Timing in PHY startup (D2.1 Comment #169)

Rev b (first presented in 9/4/19 ad hoc)

IEEE P802.3ch Multigig Automotive Ethernet PHY Task Force
George Zimmerman ((General) Ad Hoc Chair),
CME Consulting, Inc

Comment 169

tModify Figure 149_33 as attached and Include the associated Table 145.15 in section 149.4.2.4.10 page 147, line 35 to read as follows

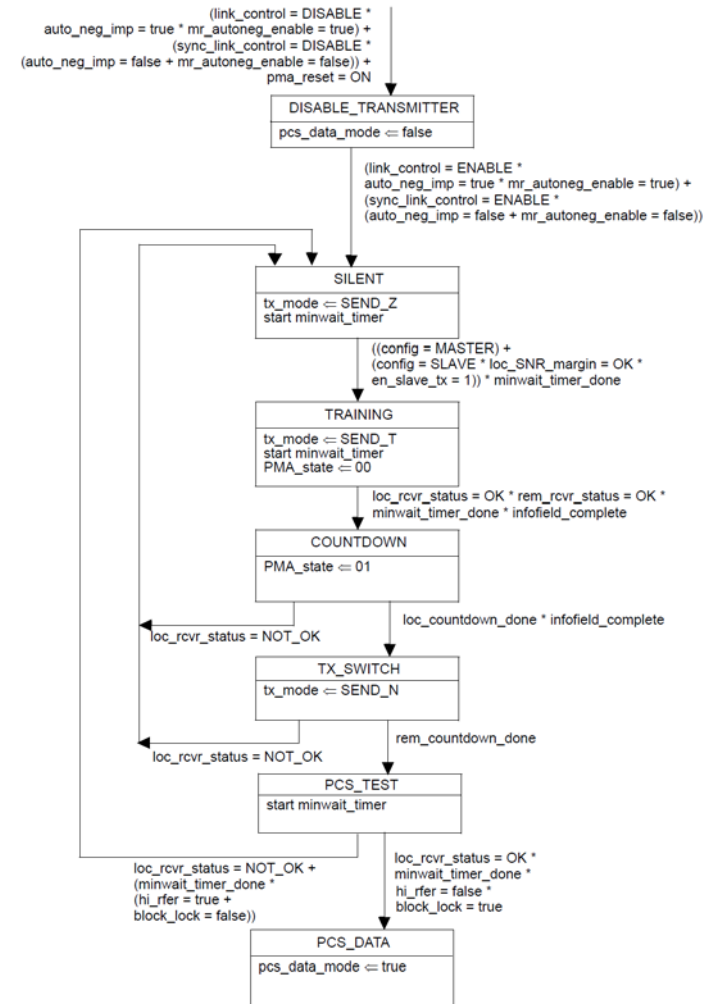
To ensure interoperability during the training phase, certain timing allocations between Master, Slave and other steps of training must be observed. We propose to the text of 802.3bz for interoperability and just scale the timing of 10G mode and deduct the timing for PCS_TEST that is set by min_wait_timer.

MASTER	SLAVE	MAX REQUIRED TIME
Traning	Silent	40.00 msec
Training	Training	57.02 msec
PCS Test	PCS Test	0.98 msec
TOTAL		98.00 msec

Insert new final paragraph to 149.4.2.4.10 Startup sequence (Page 147 line 35): "The startup timing shall comply with Table 145-15 for MASTER, and Table 145-16 for SLAVE."

Insert new tables 145-15 and 145-16 at end of 149.4.2.4.10:

Table 145-15: Startup timing maximums for MASTER

Timing Interval	Maximum time (msec)
From entry to SILENT state until en_slave_tx = 1 is transmitted	40 – 0.384/S
From entry of SILENT state until entry to COUNTDOWN state	95.975 – 0.384/S
Entry to COUNTDOWN until entry of TX_SWITCH	0.384 / S
Entry to exit of PCS TEST	1.025
Total (Entry to SILENT to exit of PCS TEST)	97 msec

Table 145-16: Startup timing maximums for SLAVE

Timing	Maximum time (msec)
Entry to exit of SILENT state	40
Entry of SILENT state to exit of TRAINING state	95.975 – 0.384/S
Entry to COUNTDOWN until entry of TX_SWITCH	0.384 / S
Entry to exit of PCS TEST	1.025
Total (Entry to SILENT to exit of PCS TEST)	97 msec
